LOCAL HISTORIC DISTRICT: Dilworth

PROPERTY ADDRESS: 712 East Park Avenue

SUMMARY OF REQUEST: Addition, window replacement

Charlotte Historic District Commission Case 2018-218
HISTORIC DISTRICT: DILWORTH
ADDITION

Bay Windows

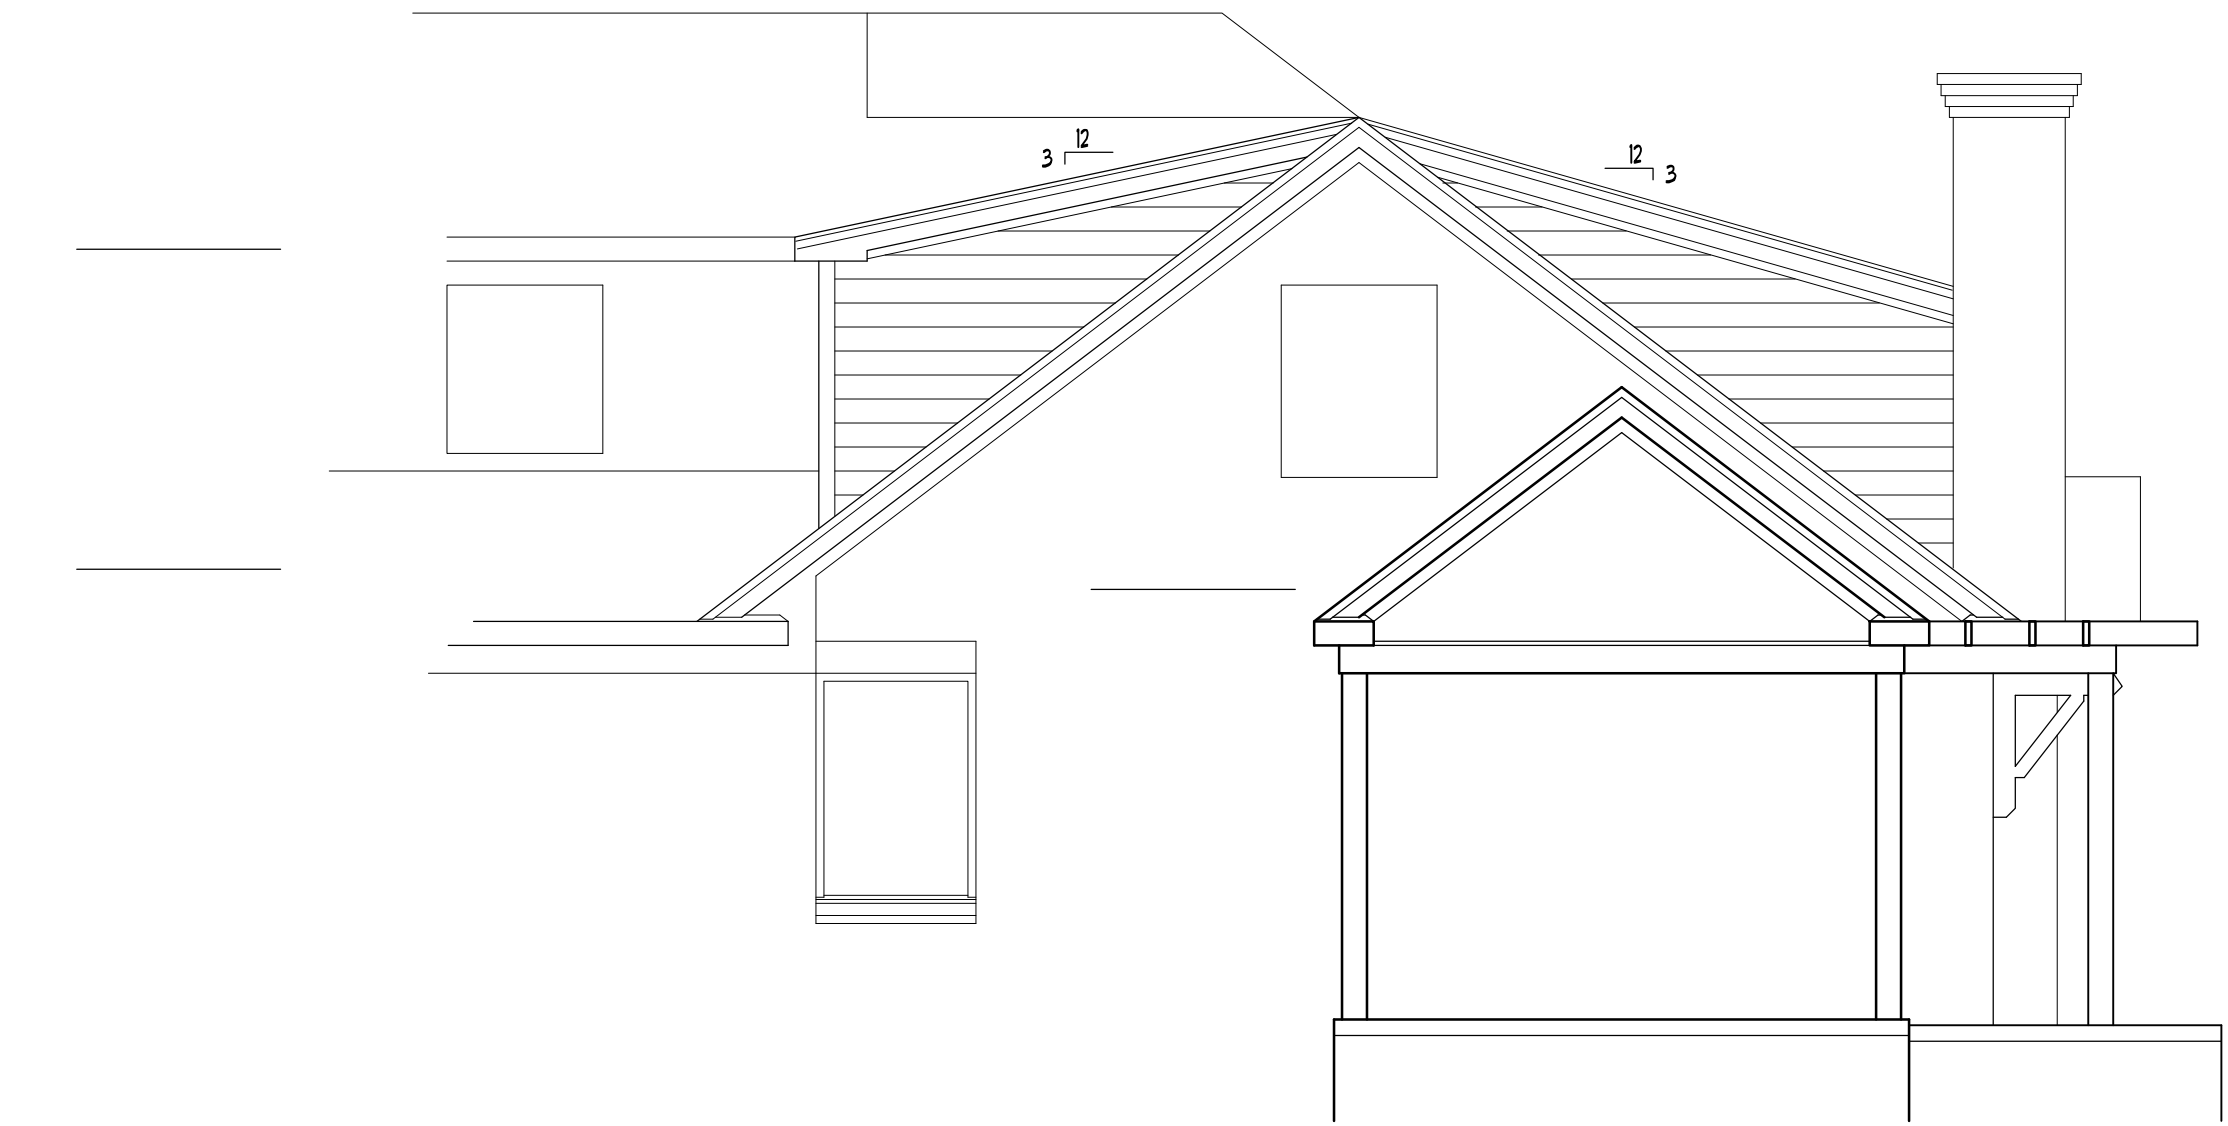
1. The applicant has provided additional information on the proposed window design to enlarge the first level window including examples of bay and paired windows within the surrounding context.
2. The scale of the dormer has been reduced.
3. Additional information has been provided for materials and dimensions.
4. Sheet A-3 includes a statement from the property owner on the preferred design.

1. The proposed bay window does not meet guideline 4.14.1 and 4.14.6. However, the HDC will determine if an exception will be granted based on the existence of similar bay window designs on the block.
2. The revisions for the porch roof and dormer meet the applicable guidelines for additions and roofs.
3. Overall, the proposal is not incongruous with the District. Minor revisions may be reviewed by staff.
